**Government of India**  
**Ministry of Railways**  
**Research, Designs & Standards Organisation**  
**Manak Nagar, Lucknow - 226 011**

No. EL/3.2.172

**Modification Sheet No. WAG 5/24** (New No. WAG5/238)

1. **Title :** Adoption of modified commutator and bearing bracket on Traction Motor type HS 15250A.
2. **Application :** Traction Motor type HS 15250A.
3. **Object :** Railways have reported that during maintenance shed people are facing lot of difficulties in attending the brush holders in assembled traction Motor type HS 15250A. This problem has been studied in detail. The main reason for this is the non availability of inspection window in the commutator end bearing bracket.

FIG. 1

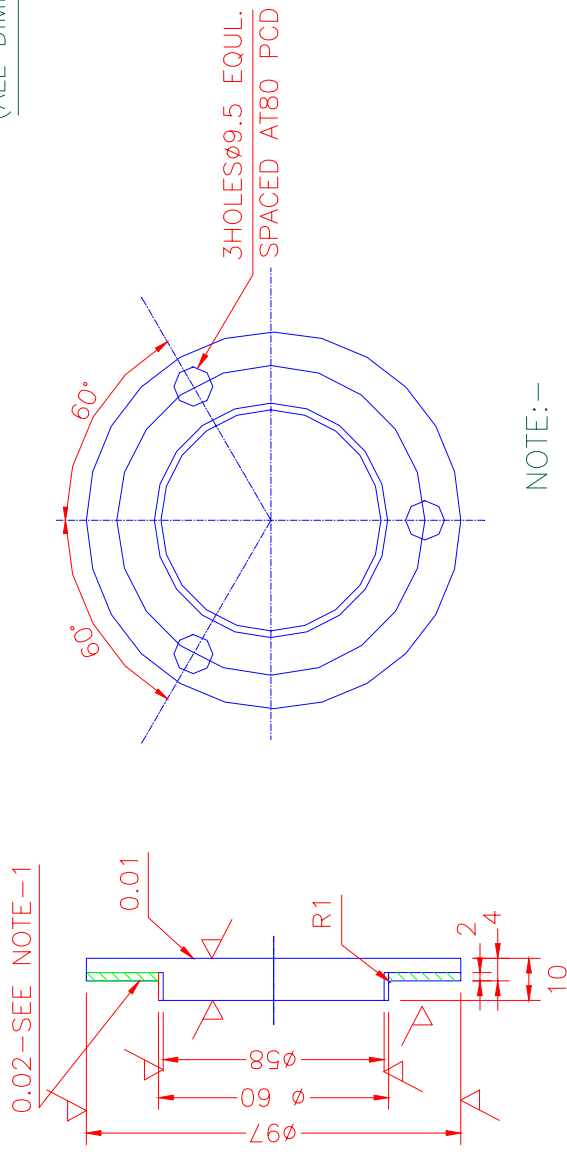
4. **Work to be carried out :**
  - 4.1 Refer the attached Fig. No.1 & 2(Copy enclosed).
  - 4.2 CE bearing bracket to be modified as shown in HH of the Fig. No.1
  - 4.3 Cover to be made as per attached Fig, No.2
  - 4.4 Before putting back motor into service ensure that hole is covered with the inspection cover.
5. **Schedule of Implementation :**
  - For Zonal Railways : During overhaul repair.
  - Production Units : On their regular production.
